## DESCRIPTIVE REPORT

Registry No.                   F00541

General Locality           Bremerton

**ATLANTIC HYDROGRAPHIC BRANCH  
EVALUATION REPORT to ACCOMPANY  
SURVEY F00541 (2007)**

## NOAA Chart 18452 Sinclair Inlet

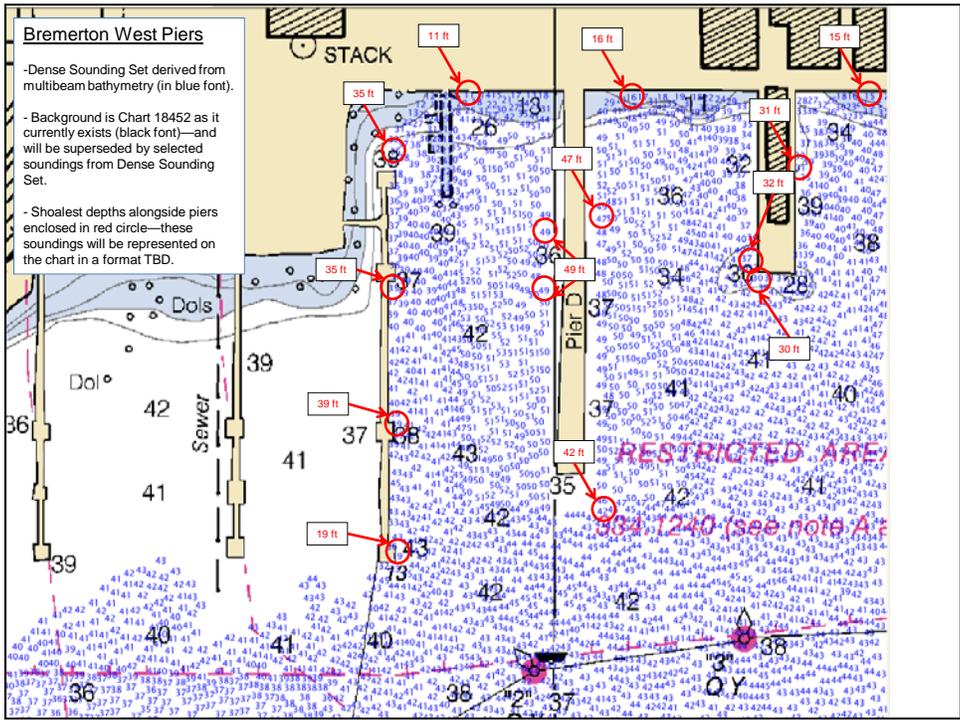
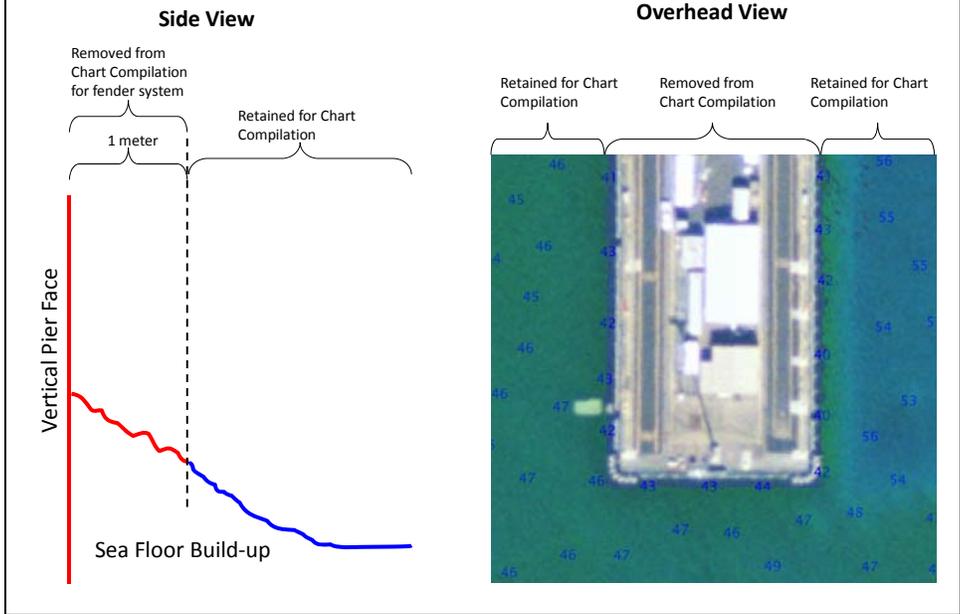
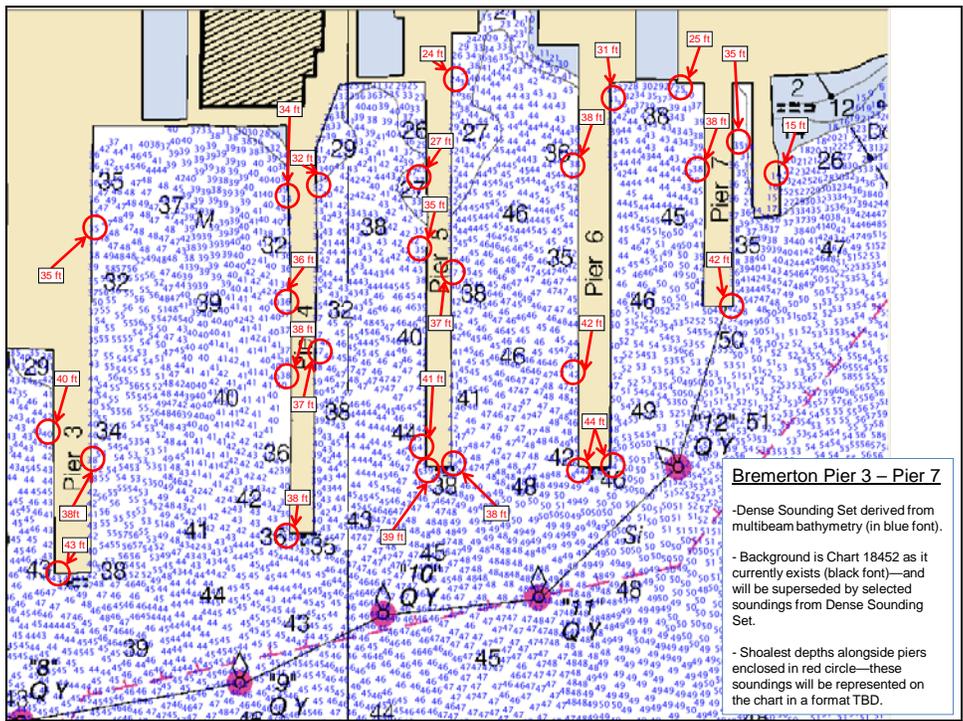
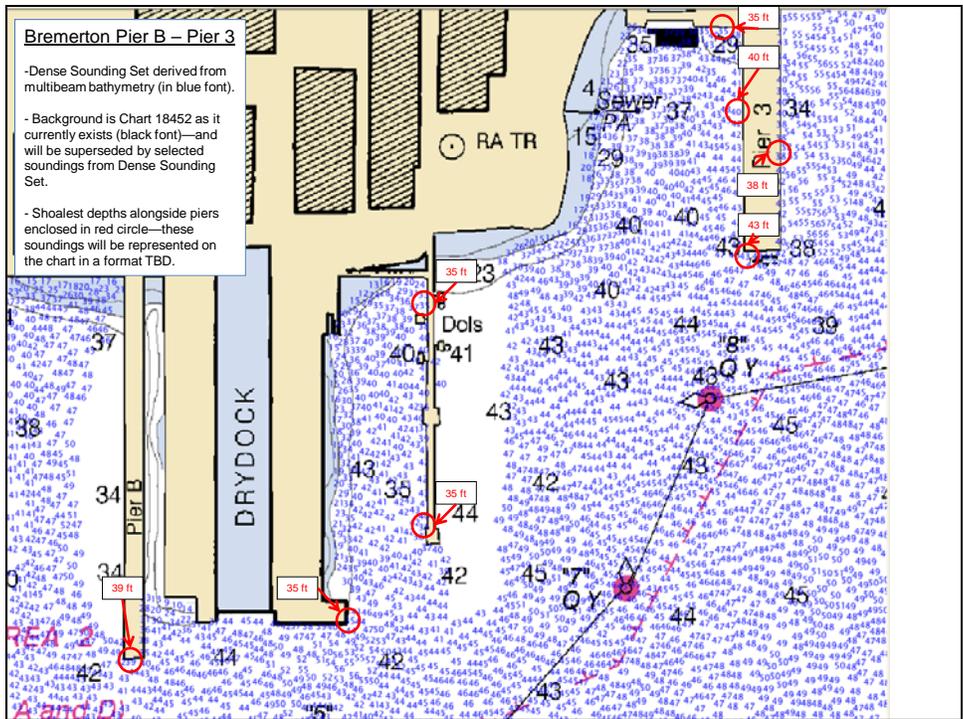
Of particular concern to Navy port facilities are the shoal depths alongside piers. In anticipation for this discussion, the multibeam data was edited around each of the Bremerton piers, such that all data falling under the piers was rejected. In addition, to account for fendering systems, all multibeam data that fell within 1m (a default value) of each pier face on the horizontal plane was rejected. This methodology is described in the screen captures to follow.

- Hydrographic Survey F00541 was conducted in and around the piers of the Bremerton Naval Base by NOAA Navigation Response Team 3 in 2007.
- Multibeam data was edited around the pier faces with the methodology described in the next slide (Slide 2).
- Multibeam data edited using orthophotos from 2008—not the raster chart (hence some soundings in the following slides may not align exactly with piers as delineated on raster chart).
